Access Compliance Report

Public Rights-of-Way

(Curb Ramps)

Intersection ID: 11650	Main Street: W_10TH_ST	Cross Street: N_CHURCH_ST	Location: W
ADA ID: 9C03C2D7F0C9	Ramp Type: PerpDiag	Initial Pass/Fail: Fail	Overall Compliance: No
Severity Score: 22.5			
Codes/Mitigation Info/Possible Solution		Field Measurements/Component Compliance

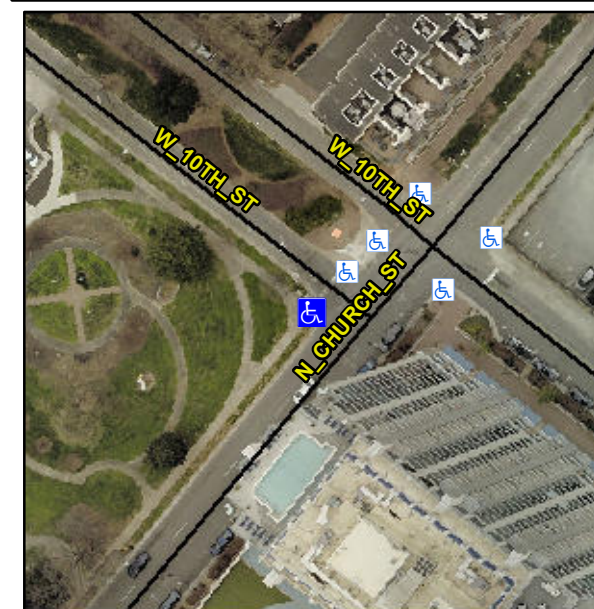
Not Found, R304.5.1, R304.2.2, R304.5.3

Compliance	Description	Data	Compliance	Description	Data
N/A	Ramp Length (in)	40.0	No	Ramp Slope (%)	9.9
No	Ramp Width (in)	36.0	No	Ramp XSlope (%)	4.9
N/A	Flare Type LT	N/A	N/A	Flare Type RT	N/A
N/A	Flare Slope LT (%)	N/A	N/A	Flare Slope RT (%)	N/A
N/A	Flare Traversable LT?	N/A	N/A	Flare Traversable RT?	N/A
N/A	Landing Length (in)	N/A	N/A	DWS Provided?	N/A
N/A	Landing Width (in)	N/A	N/A	DWS Contrast?	N/A
N/A	Landing Slope (%)	N/A	N/A	DWS Length (in)	N/A
N/A	Landing X Slope (%)	N/A	N/A	DWS Full Width?	N/A
N/A	Landing Curb? (Y/N)	N/A	N/A	DWS Offset (in)	N/A
N/A	Shared Landing?	N/A			
N/A	Gutter Ponding?	N/A	N/A	Gutter Slope (%)	N/A
N/A	Gutter Lip Ht (in)	N/A	N/A	Gutter X Slope (%)	N/A
N/A	Painted X Walk1?	No	N/A	Painted X Walk2?	No
	X Walk 1 Direction	To E		X Walk 2 Direction	To NE
N/A	X Walk 1 Width (in)	N/A	N/A	X Walk 2 Width (in)	N/A
	X Walk 1 Slope (%)	3.8		X Walk 2 Slope (%)	0.1
	X Walk 1 X Slope (%)	0.3		X Walk 2 X Slope (%)	1.0

Remove & Replace Curb Ramp With Two New Directional Ramps or Equivalent.
